Diversity Issues with the DLRU Subchannelization (Section 15.3.5.2.1 and 15.3.8.2.1)

C802.16m-09/2530

Re: P802.16m/D2 comments for LB30a

Area: Section 15.3.5.3.1 – DL PHY Structure and Section 15.3.8.3.1 – UL PHY Structure

Maximum allowed number of NLRUs

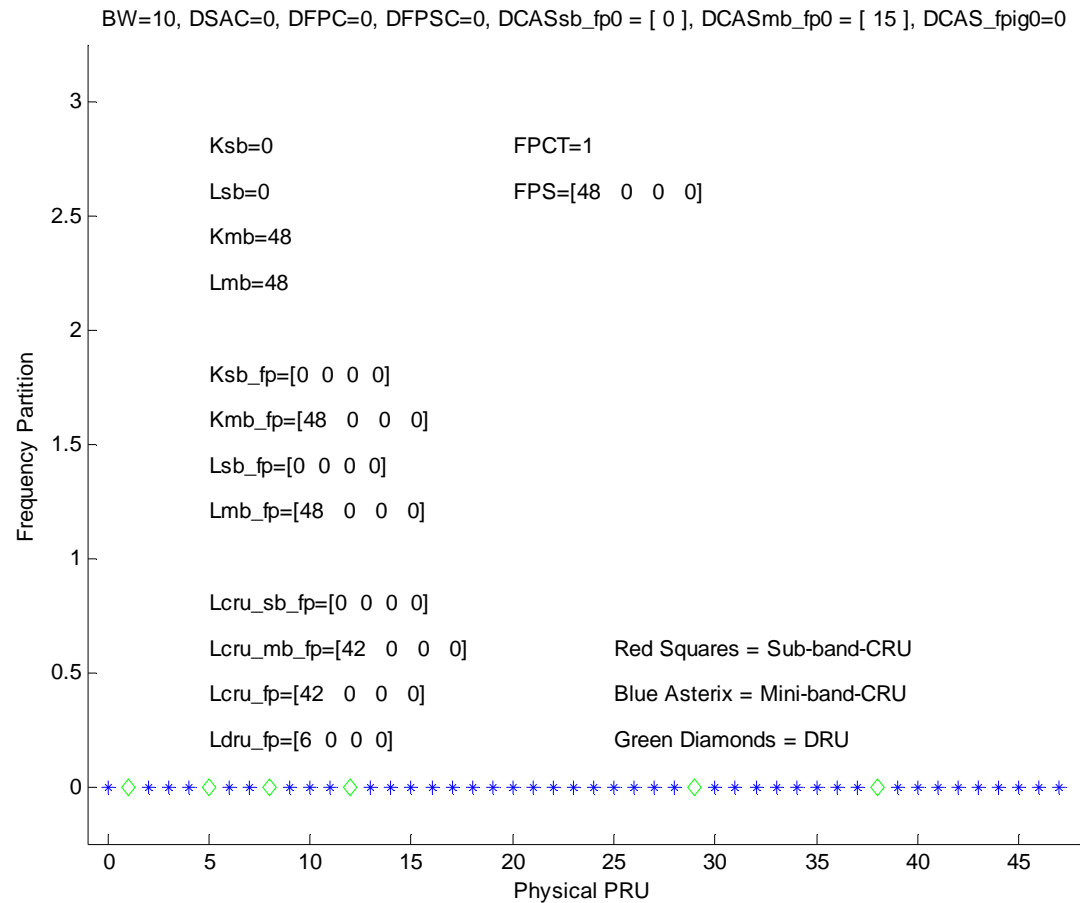
- UMa / RMa Configuration
- One Frequency Partition
- DRUs are distributed across the bandwidth
 - OK for Diversity
